State of Utah
Department of Commerce
Division of Public Utilities

DIVISION COMMENTS ON PACIFICORP'S 2015 IRP

Subject: Docket No. 15-035-04, PacifiCorp's 2015 Integrated Resource Plan

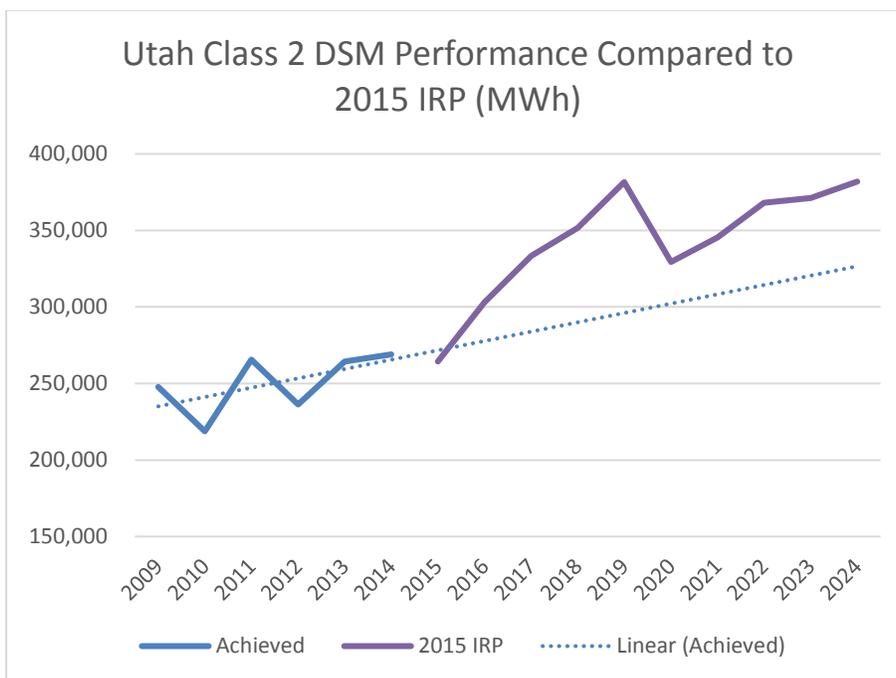
percent of planned, new long-term resources. Class 2 DSM was unable to achieve the 2013 IRP estimate that was considerably lower than what is modeled in the 2015 IRP preferred portfolio. The chart below provides the estimated performance of Utah Class 2 DSM, in megawatt hours, for the 2015 IRP preferred portfolio for the first ten years of the planning cycle (2015 through 2024). The chart also contains the actual performance of the estimated Utah Class 2 DSM megawatt hours achieved for the periods 2009 through 2014.²⁹

The above graph also contains a trend line, based on actual Class 2 DSM performance for 2009 through 2014, of the estimated achieved Class 2 DSM resources that could be reached for the years 2015 through 2024.

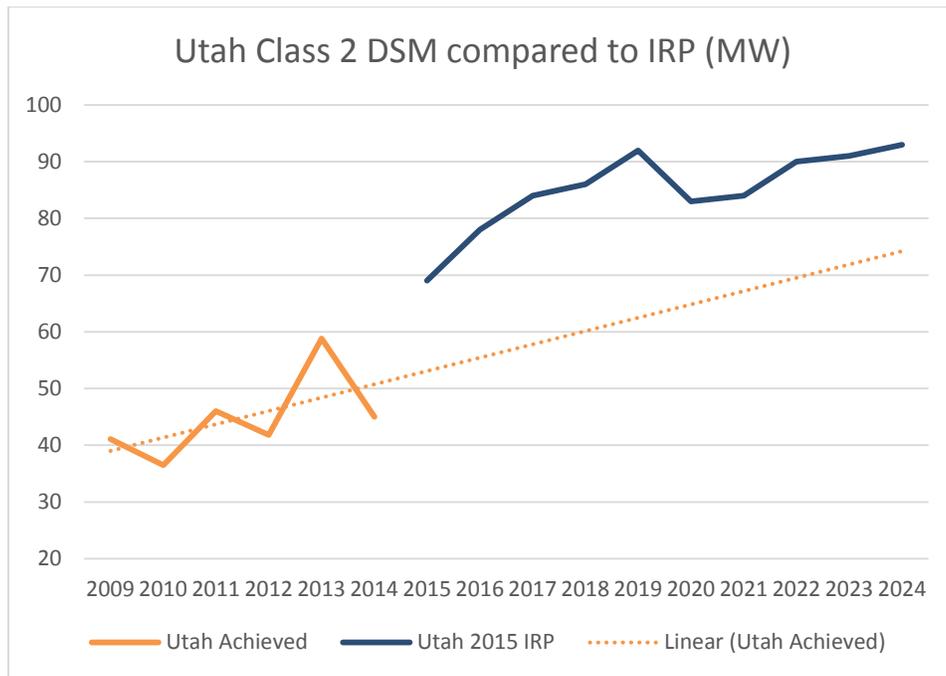
The 2015 IRP Class 2 DSM increases significantly from what the trend line suggests is achievable, based on the past performance of DSM in Utah. Even with the forecasted downturn in 2020, the Class 2 DSM resources in the 2015 IRP maintains a markedly higher level than the estimated achieved trend line.

The chart above indicates that the trend line for the Utah achieved megawatts is considerably less than the 2015 IRP Utah Class 2 DSM estimate. If the estimated DSM is not achieved, then the Company may be compelled to rely on even more FOTs that may put customers at risk for higher prices.
